UNITED STATES PATENT AND TRADEMARK OFFICE

-	APPLICATION NO.	FILING	DATE	FIRST NAMED INVENTOR	ATTORNEY DOCKET NO.	CONFIRMATION NO.	1
10/804,637		03/19	/2004	Michael E. Shirk	18030B1	7748	
	23307	7590	11/17/2005		EXAM	INER	
	SYNNESTV	EDT & LE	CHNER, LLP		HARVEY, JAMES R		
	2600 ARAMARK TOWER 1101 MARKET STREET				ART UNIT	PAPER NUMBER	7
	PHILADELP		91072950	2833

X /				
		Applicati	on No.	Applicant(s)	1				
		10/804,6	37	SHIRK ET AL.					
	Office Action Summary	Examine	r	Art Unit					
		James R.		2833					
Period fe	The MAILING DATE of this communication apports or Reply	pears on the	e cover sheet wit	h the correspondence addr	ess				
THE - External after - If the results of the result	MORTENED STATUTORY PERIOD FOR REPL' MAILING DATE OF THIS COMMUNICATION. ensions of time may be available under the provisions of 37 CFR 1.1 r SIX (6) MONTHS from the mailing date of this communication. e period for reply specified above is less than thirty (30) days, a repl o period for reply is specified above, the maximum statutory period of the properties of the prop	36(a). In no ev ly within the stat will apply and w e, cause the app	ent, however, may a re tutory minimum of thirty rill expire SIX

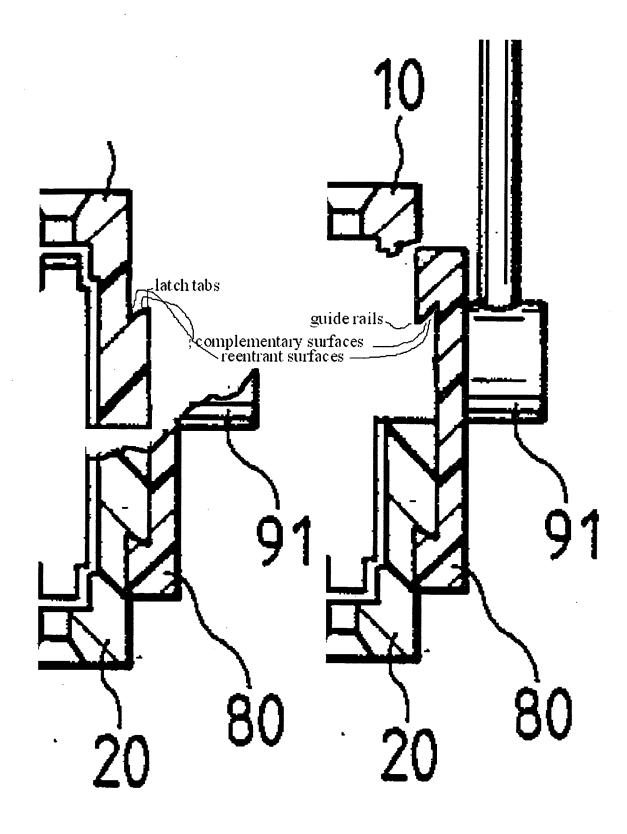
-- In reference to Claim(s) 4, Ichimura shows (see examiner's figure)

the lever and the actuator are mounted to a housing 20, the housing having a mounting boss 80 defining guide rails (see examiner's figure), the actuator having latch tabs (see examiner's figure) defining complementary surfaces for latching to the guide rails, the guide rails and the latch tabs cooperating to allow relative translational motion between the guide rails and the latch tabs.

-- In reference to Claim(s) 5, Ichimura shows (see examiner's figure)

the guide rails define reentrant surfaces (see examiner's figure), and the latch tabs define complementary reentrant surfaces (see examiner's figure) for latching to the guide rails.
